INDESIT company

Model type:
IDL60EU.2

Commercial code:
F032216

N1045072FIG1

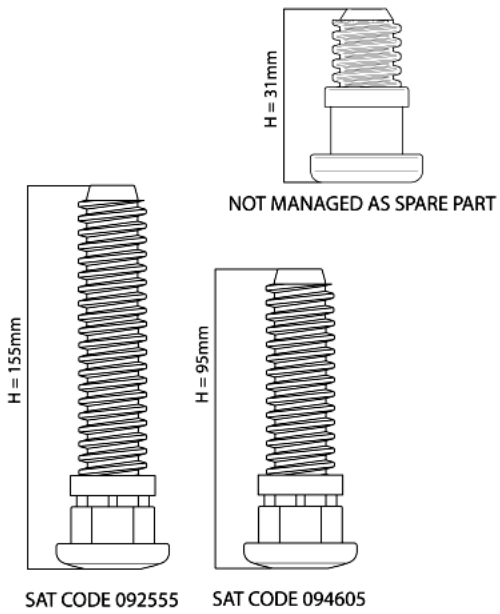
N1045072: Introduction of fixed rear foot H=31mm on free-standing models.

From serial no. 40218.0001, free-standing dishwashers affected by this modification have been equipped with new fixed rear feet (H=31mm).
The new foot replaces the adjustable one (H=155mm) Service code 092555; on the EVO3 range with TurboDry the new foot replaces the adjustable foot (H=95mm) Service code 094605.
The Spare Part Warehouse will continue to manage only 155mm and 95mm adjustable feet as they are interchangeable with the fixed 31mm foot.
The three feet are shown in illustration N1045072FIG1.

N1045080FIG1

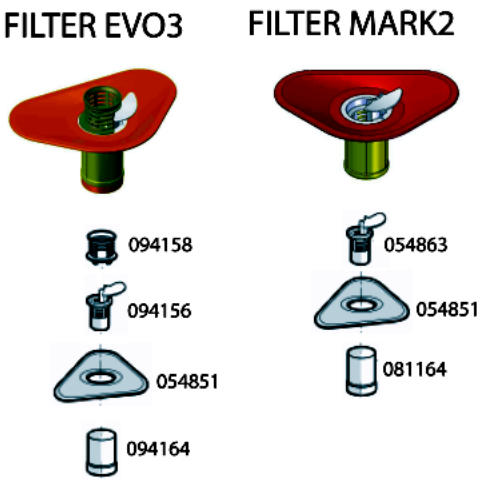
n1045080: Modification of front feet on free-standing DW.

From serial no. 40413.0001, free-standing dishwashers affected by this modification have been equipped with new front feet Service code 109991 in place of 056414.
The new foot is shown in fig. N1045080FIG1.

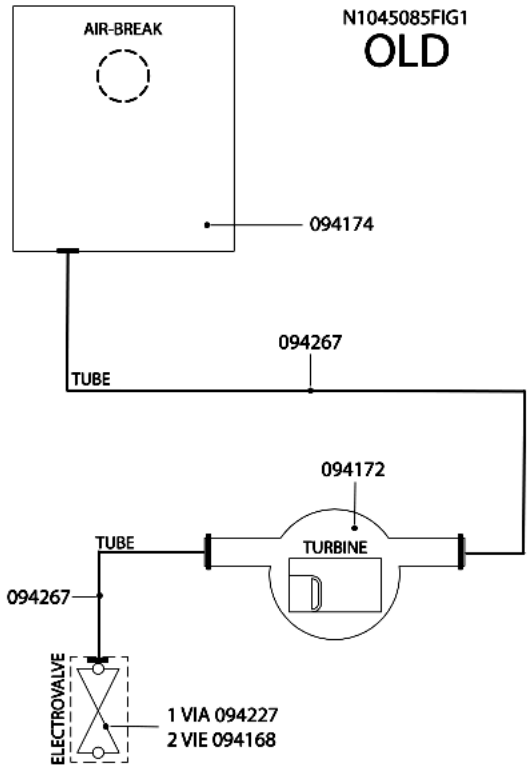
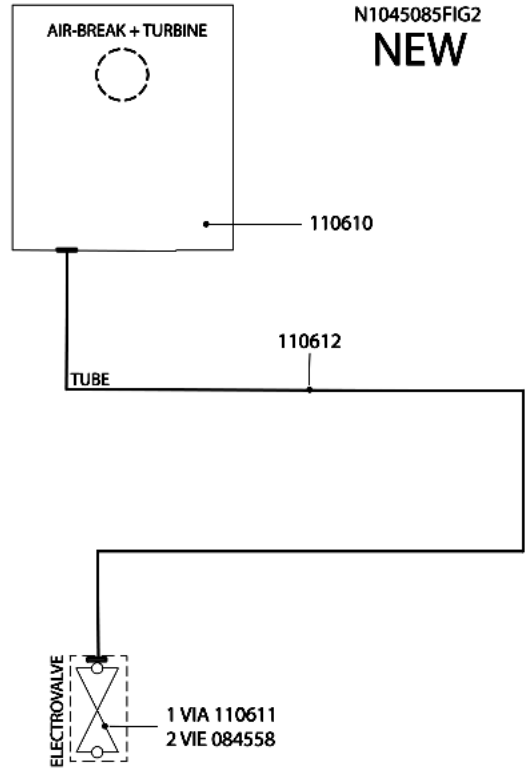
n1045085: Introduction of new litre counter turbine integrated on air-break.

All dishwashers affected by this note have been equipped with a new litre counter turbine on the air-break.
Picture N1045085FIG1 illustrates the premodification structure, picture N1045085FIG2 the new structure.

AIR-BREAK:
new 110610;
premodification 094174;
the new item features a new integrated litre counter turbine and its water supply hose has a smaller diameter.

LITRE COUNTER TURBINE code 094172 has been eliminated.

SOLENOID VALVES:
new:
1-WAY code 110611;
2-WAY code 084558(Rohs 143737);
premodification:
1-WAY code 094227;
2-WAY code 094168;
the new solenoid valves have a smaller diameter drain hose fitting.

HOSES:
new solenoid valve hose/air-break code 110612;
premodification turbine hose/air-break code 094267;
premodification solenoid valve hose/air-break code 094267;
the new hose has a smaller internal diameter.

WIRING:
the litre counter turbine connecting cable is longer, but since the connector is the same, the new item can be used in place of the premodification one.
